**RE:** **Four Seasons Plaza, Lot 2 (Panera Bread):** An Amended Site Development Plan, Amended Landscape Plan, Partial Amended Lighting Plan, Amended Architectural Elevations and an Architect's Statement of Design for an 8.29 acre tract of land zoned "PC" Planned Commercial District located on the south side of Olive Boulevard west of its intersection with Woods Mill Road.

## Planning Commission Staff Report

**Description:** **Four Seasons Plaza, Lot 2 (Panera Bread)**: An Amended Site Development Plan, Amended Landscape Plan, Partial Amended Lighting Plan, Amended Architectural Elevations and an Architect's Statement of Design for an 8.29 acre tract of land zoned "PC" Planned Commercial District located on the south side of Olive Boulevard west of its intersection with Woods Mill Road.

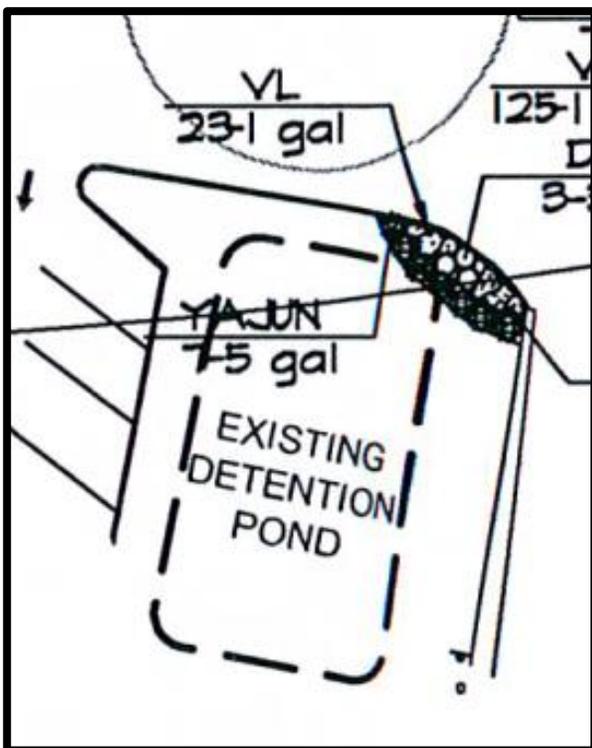
The amendments to the Architectural Elevations include slightly increasing the height of the subject area, as shown in the comparison below. Whereas the existing endcap space is dwarfed by the adjacent portion of building, adding height to the building will alter the scale to be more consistent with the adjacent section of the building. The canopies and wainscot provide a pedestrian scale despite the height increase.

Landscaping around detention area as presented at ARB

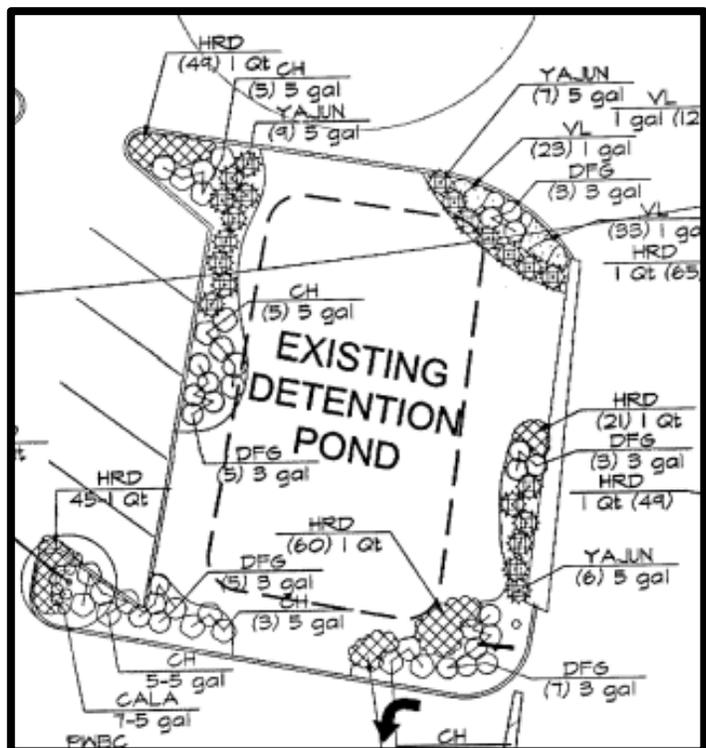
3. Additionally, the ARB suggested that the applicant consider replacement of and/or additional landscaping around the split rail fence that surrounds the detention area north of the subject tenant area.

Finally, in response to the ARB's third recommendation, the applicant has revised the Landscaping Plan to include substantial landscaping around the split rail fence and detention area. Below is a side by side comparison of this area.

Landscaping around detention area in current Landscape Plan
